Public Comment No. 13-NFPA 99-2022 [Global Input]

Correlating Committee Note No. 12-NFPA 99-2022 [New Section after 5.3]

First Revision No. 1088-NFPA 99-2021 [New Section after 5.3]

Figure A.5.1.3.10(a) Distances Between Bulk Oxygen Systems and Exposures.
[55:Figure A.9.3.2]

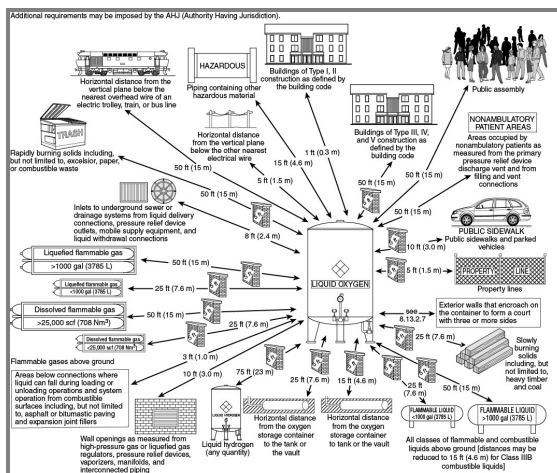
For bulk oxygen systems, see NFPA 55. Figure A.5.1.3.10(a) illustrates the separation distances between bulk oxygen systems and exposures. Figure A.5.1.3.10(b) illustrates two possible choices of oxygen reserves. Both are not required.
